HPC Staff met with George Pfeifer and Mike Killa of Authentic Construction on June 10, 2015 to discuss the proposal for a three stall garage at the alley. Staff suggested that the proposed garage be re-oriented to the existing historic driveway to avoid adverse impacts to the historic alley wall. The applicant submitted plans that reflected staff's recommendation for a driveway oriented garage as an Option 2 with their December 22, 2015 application, but indicated that Option 1 plans were being put forward for review.

Freestanding garage on property at 389 Portland Avenue St Paul

SPECIFICATIONS FOR A PROPOSED GARAGE

GARGAE PLAN
ELEVATIONS
1/4" = 1 FT

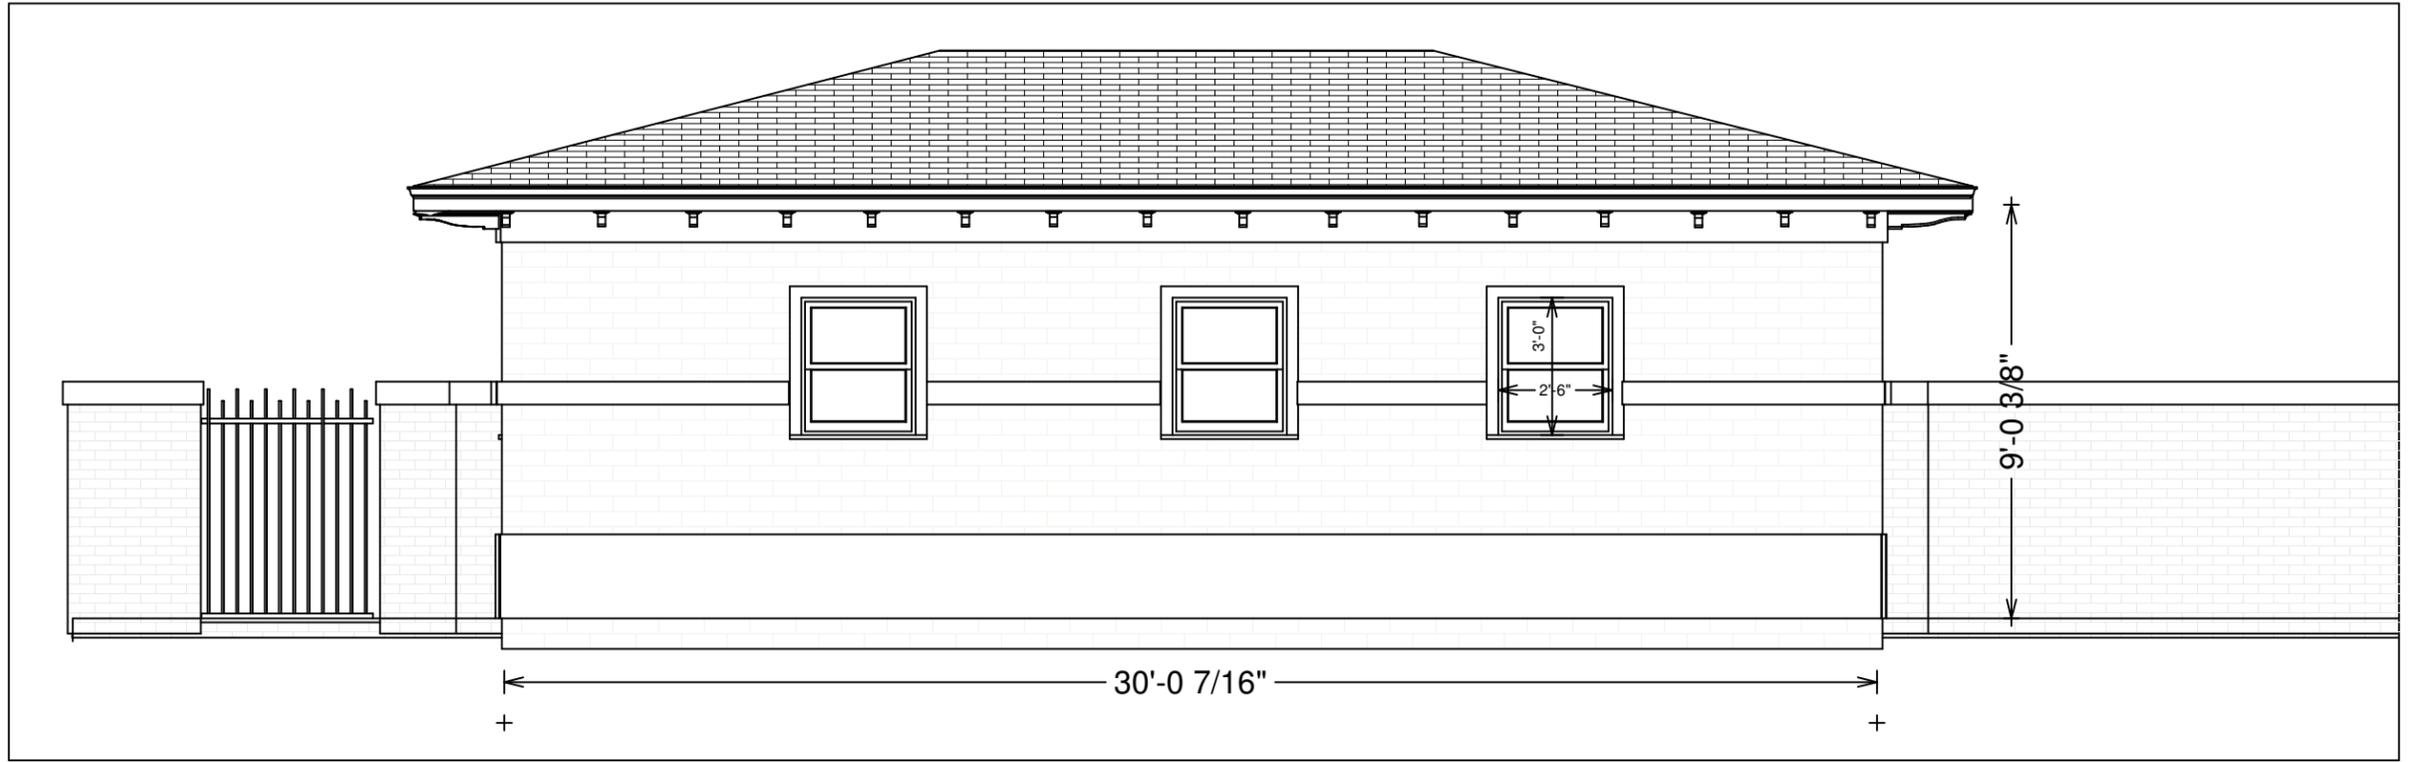
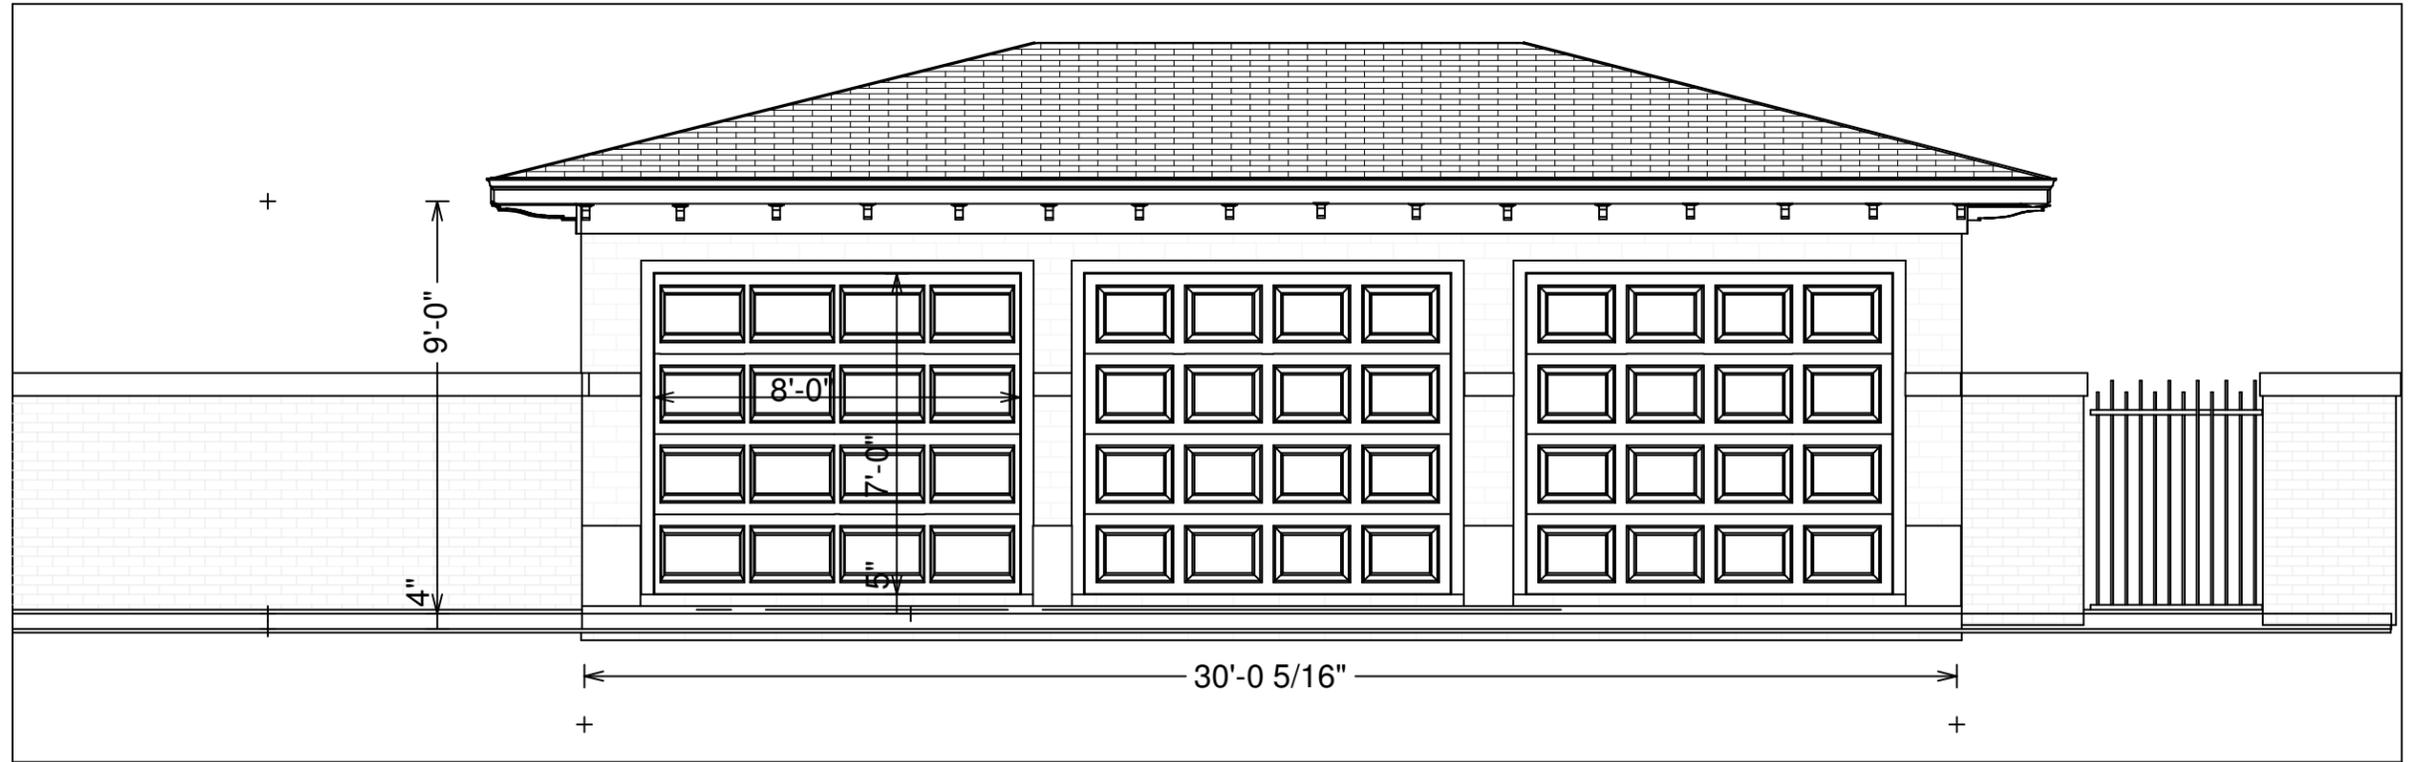
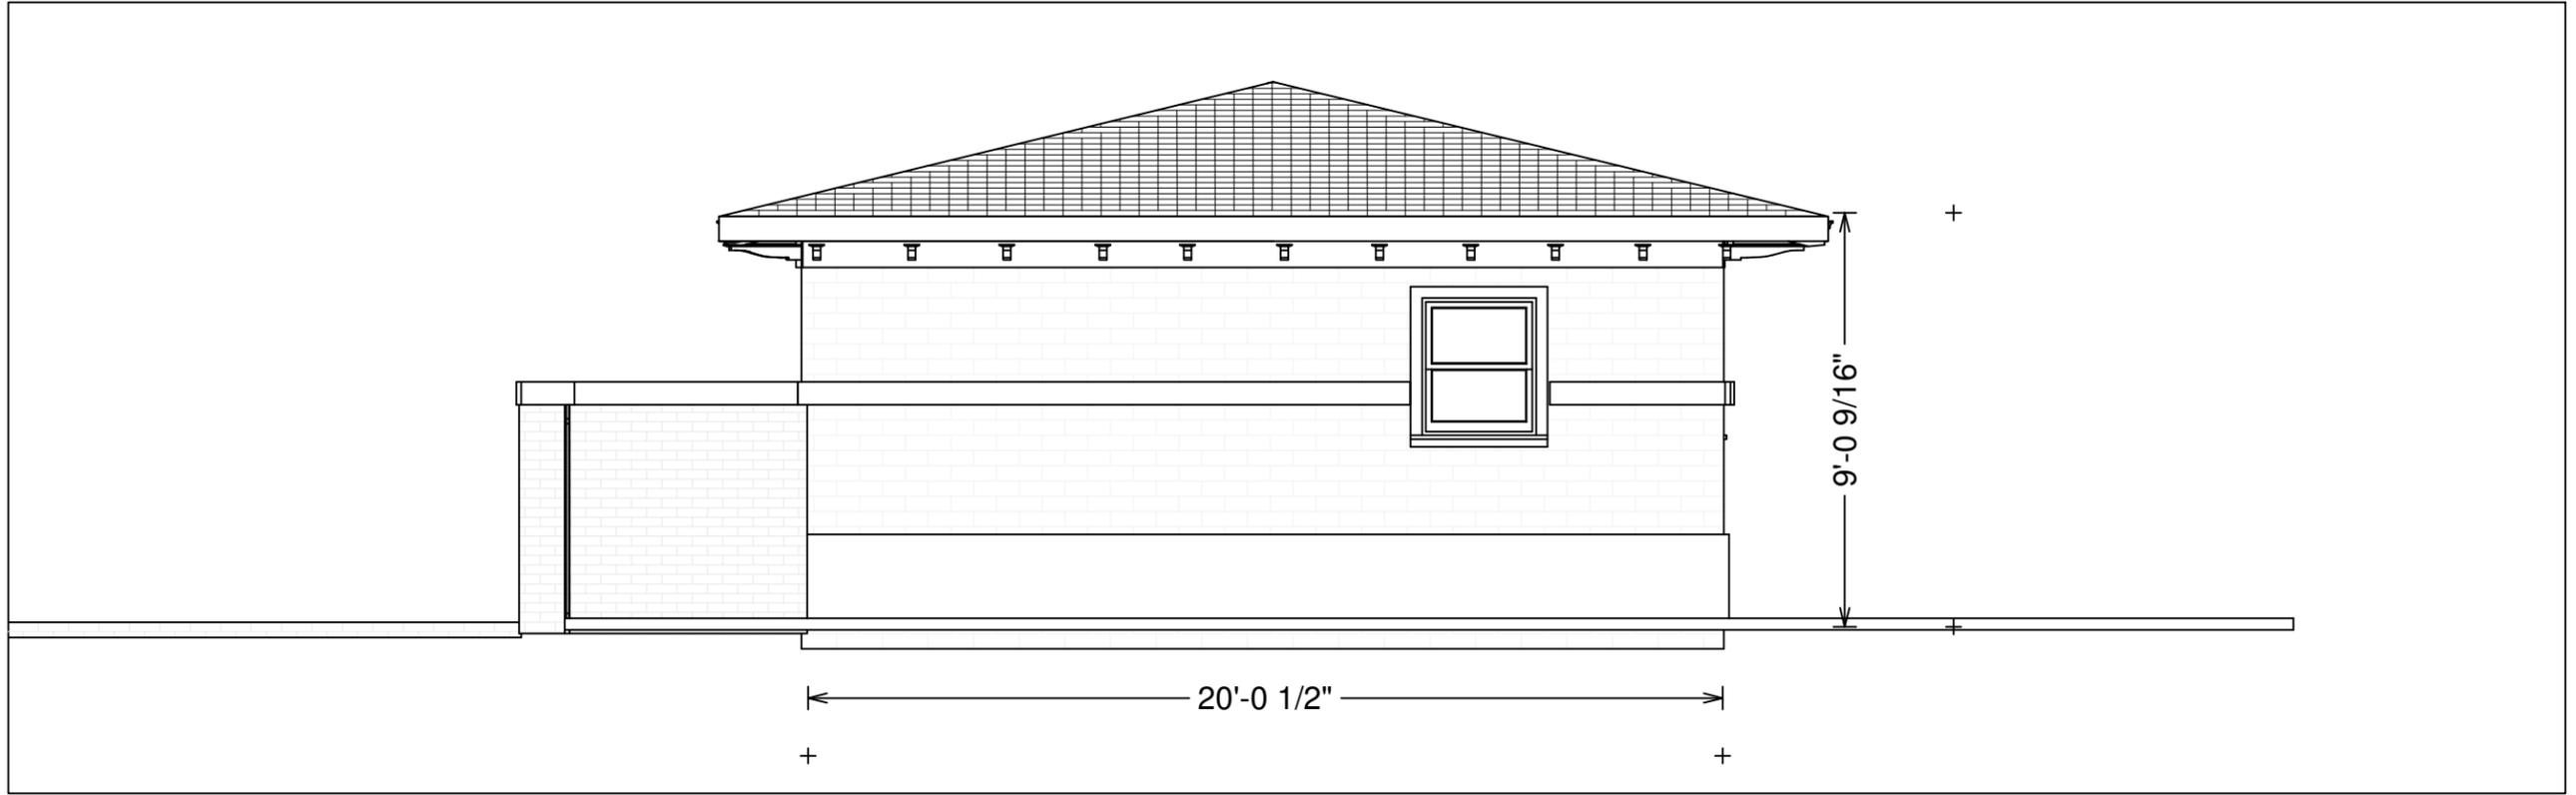
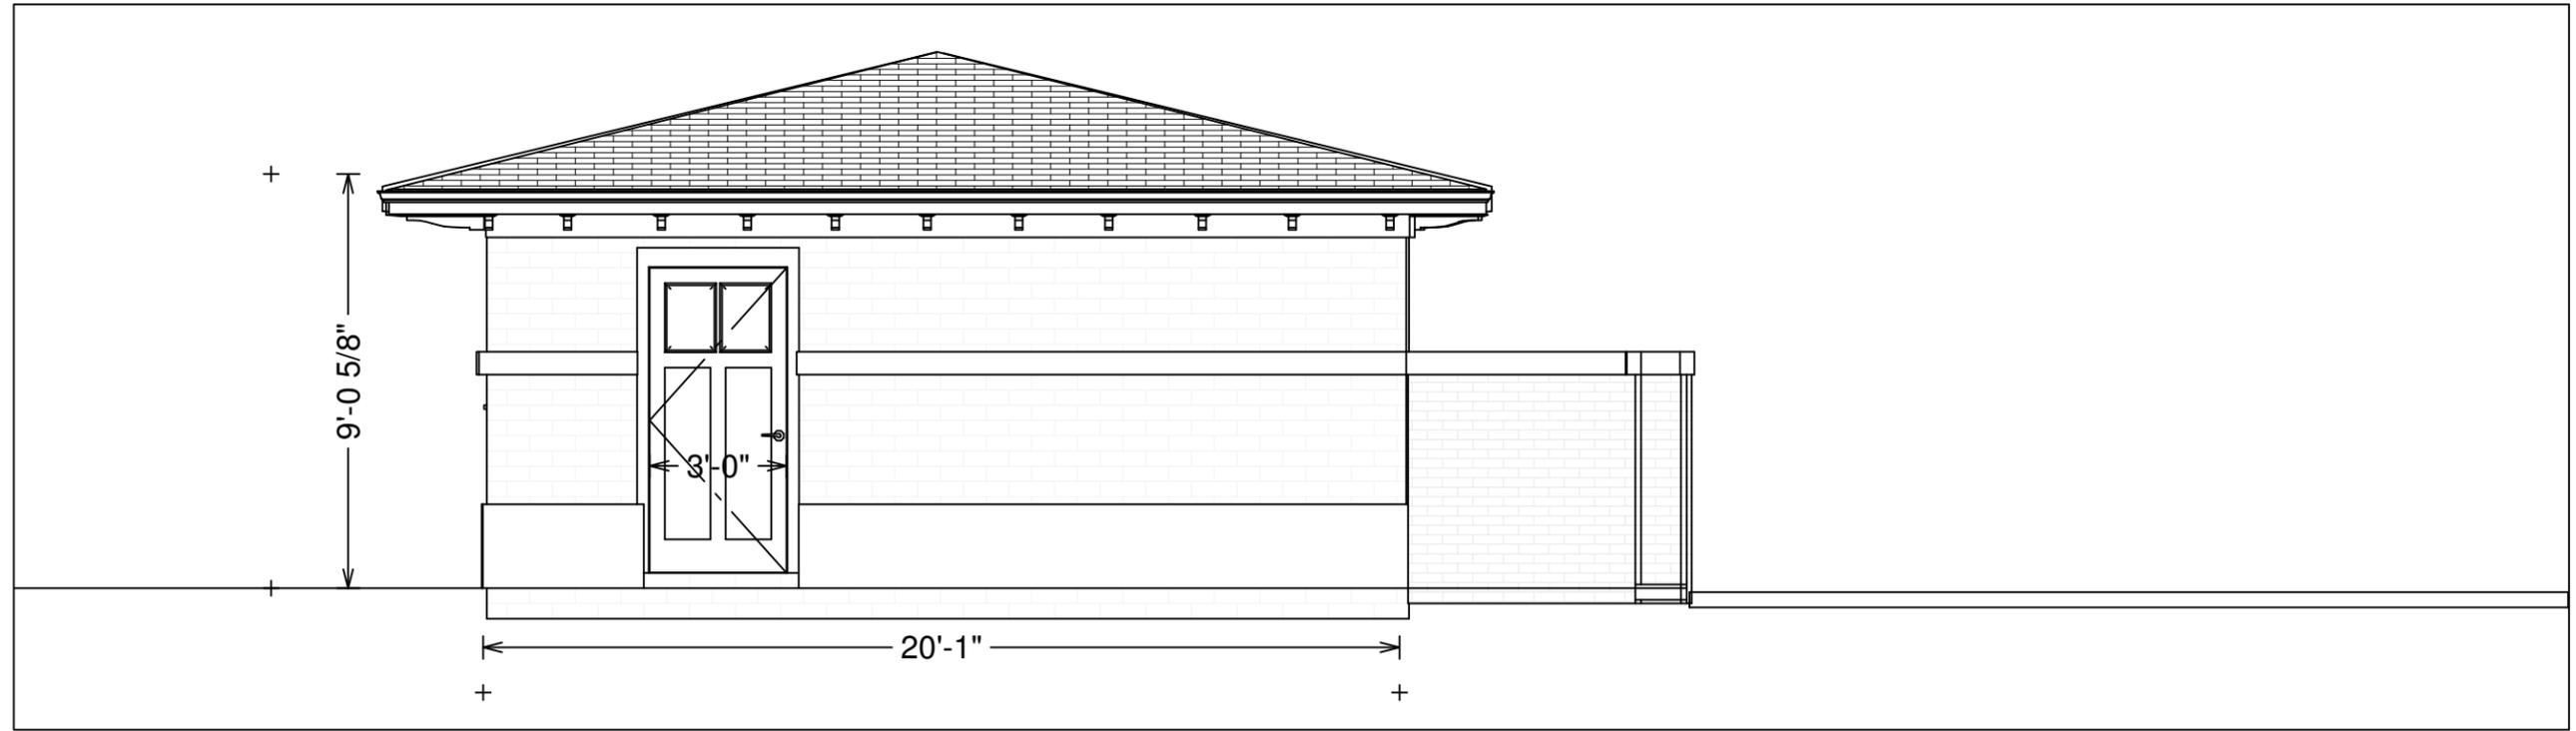
3. **Sec. 74.65(d) Materials and Details:** The *materials and details* of the proposed garage relate to those of the residence, but in a more simple design. The smooth stucco base of the garage does not relate to the limestone base of the residence. A concrete block or face brick from grade as alternately proposed would better relate to the main house.

4. **Sec. 74.65(e)(1) Roofs:** The roof shape and material matches that of the residence and complies with the guideline so long as the shingle color is medium to dark grey or medium to dark brown.

5. **Sec. 74.65(e)(2) Windows and Doors:** The windows are proposed to be Marvin wood, double-hung windows. The proportion and style of the garage windows compliment those on the residence. The service door and garage doors are proposed to be paneled and of a painted fiberglass or steel.
